DOCKET NO.: 20200001-EI

(CONFIDENTIAL) Hearing Exhibit No. 115 from 2/4/20 DOAH Hearing. [CLK Note: See DN 10935-2019 for Exh Nos. 1, 68-75, 80, 82, 100]

DESCRIPTION: RCA Draft Exhibit

OPC RCA EXHIBIT Table of Contents

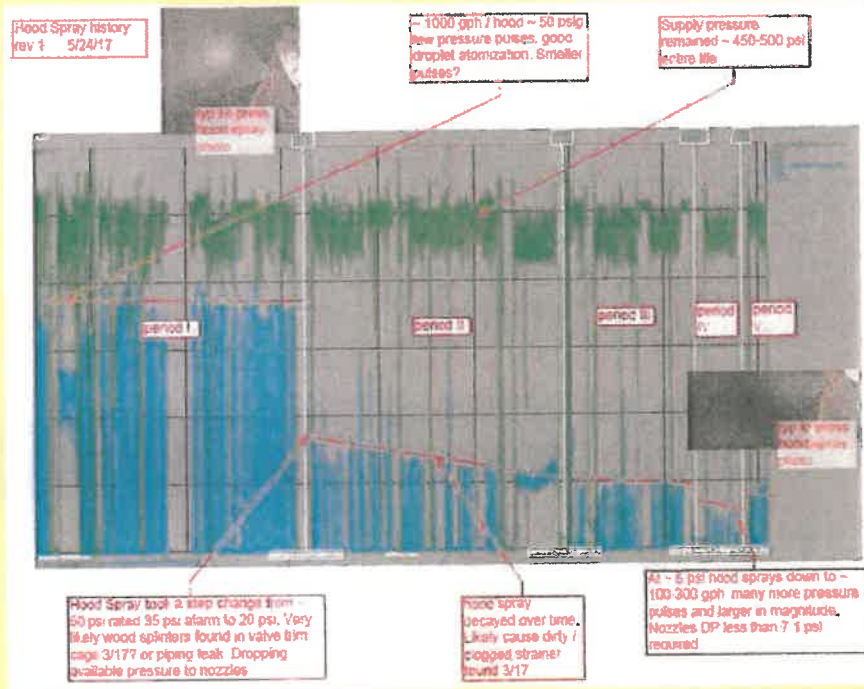
Commented [JCE5]: Which valve is this -- The control valve mentioned in the above paragraph?

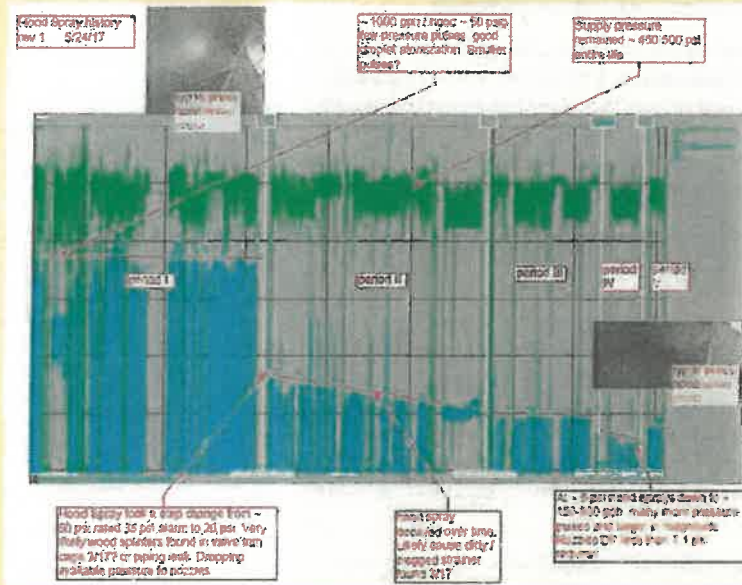
Commented [JCE4]: Paul, I changed the middle column to hours (from day) to stay consistent with other charts we've created. The hours I have for Period 1 (21,734) – do they include the time frame you've included next to the first *, or are they Period 1 operating hours post-COD?

Commented [JCE5]: Which valve is this – The control valve mentioned in the above paragraph?

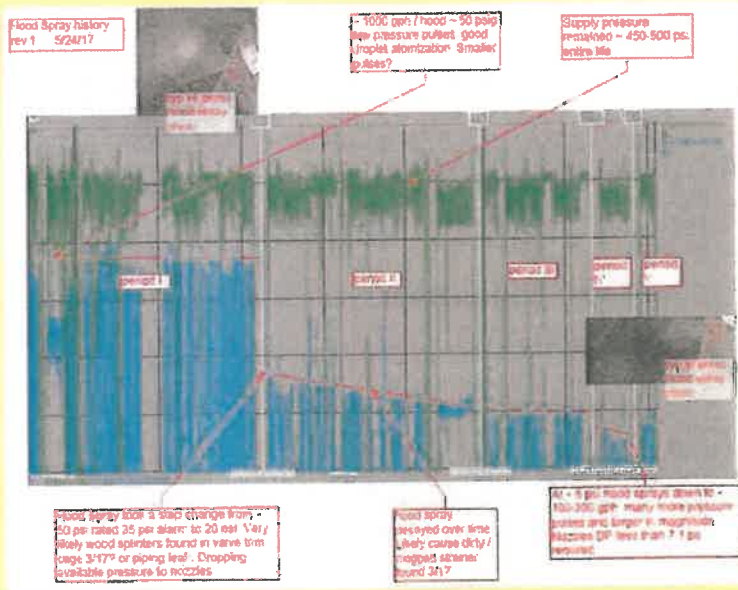
Commented [JCBA]: Paul, I changed the middle column to hours (from day) to stay consistent with other charts we've created. The hours I have for Period 1 (21,734) – do they include the time frame you've included next to the first *, or are they Period 1 operating hours post-COD?

Commented [JCBS]: Which valve is this – The control valve mentioned in the above paragraph? Yes.
